## REVISED RESPONSE TO REQUEST FOR ADDITIONAL INFORMATION

### APR1400 Design Certification

Docket No. 52-046

RAI No.: 434-8352  
SRP Section: SRP 19  
Application Section: 19.1  
Date of RAI Issue: 03/08/2016

Updated Risk Insights and Key Assumptions

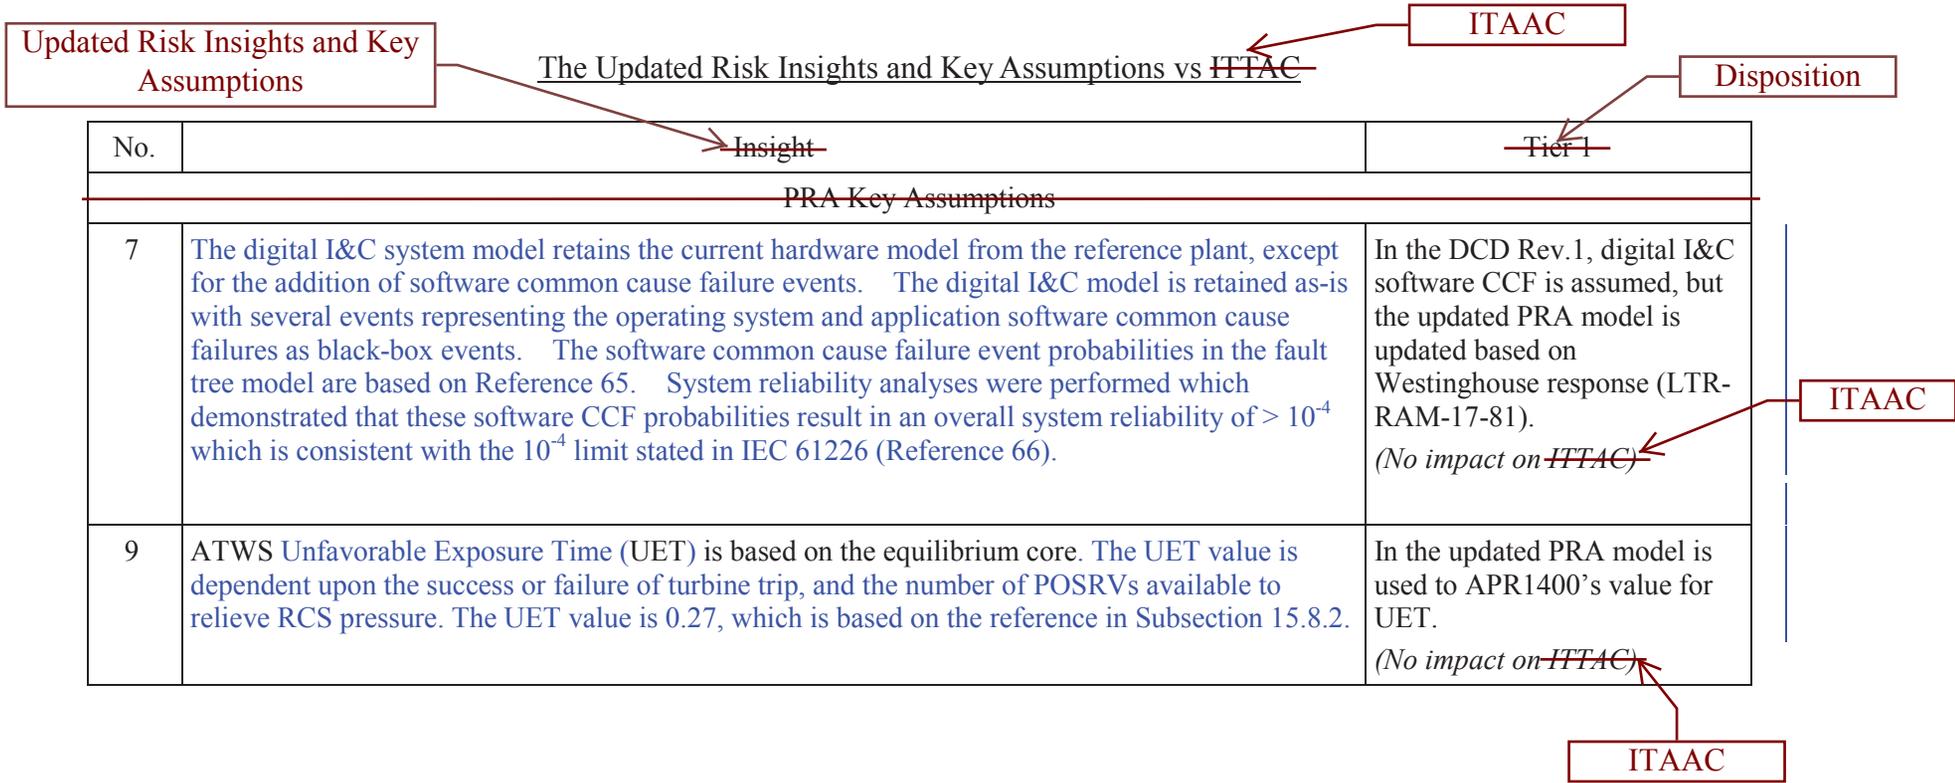
No.	<del>Insight</del>	<del>Tier 1</del>
<del>PRA Key Assumptions</del>		
5	<p>Room cooling is assumed not to be needed for the following rooms. Room heat-up calculations performed in individual rooms demonstrated that given loss of failure of all HVAC and the cubicle cooler in the room, the temperature would not exceed the NUREG/CR-6850 Appendix H solid-state control components thermal damage failure criteria of 150°F for up to 72 hours with the exception of the train C IP&amp; DC equipment and battery rooms which reaches 150°F at about 16 hours. 16 hours is assumed to be adequate time for operators to take compensatory measures such as opening doors (calculations assumed doors were closed), and setting up portable fans. Analyses were performed on the following rooms, and it is assumed (due to symmetry in the Auxiliary Building) that the calculation is applicable to redundant rooms (e.g., analysis of 1E 4KV SWGR Room 01A is applicable to the same rooms for 01B, 01C and 01D):</p> <ul style="list-style-type: none"> <li>TURBINE DRIVEN AFW PUMP RM (078-A15C)</li> <li>CLASS 1E SWITCHGEAR 01A RM (078-A25A)</li> <li>480V CLASS 1E MCC 01A RM (100-A12A)</li> <li>480V CLASS 1E MCC 03A RM (137-A23A)</li> <li>CLASS 1E LOAD CENTER 01C RM (078-A03C)</li> <li>DG CONTROL PANEL RM (100-A02C)</li> <li>SWING LOAD CENTER RM (078-A58B)</li> <li>TRAIN-A/C DC&amp;IP EQUIPMENT RM (078-A56A, 078-A05C)</li> <li>TRAIN-C BATTERY RM (078-A07C)</li> <li>PENETRATION MUX A RM (137-A17A)</li> <li>I&amp;C EQUIPMENT RM (157-A19C, 157-A01D)</li> <li>480V CLASS 1E MCC 03B RM (120-A15B)</li> </ul>	<p>In the DCD Rev.1, the room cooling is assumed. The room heatup calculation for APR1400 is prepared.</p> <p><del>(No impact on ITAC)</del></p>
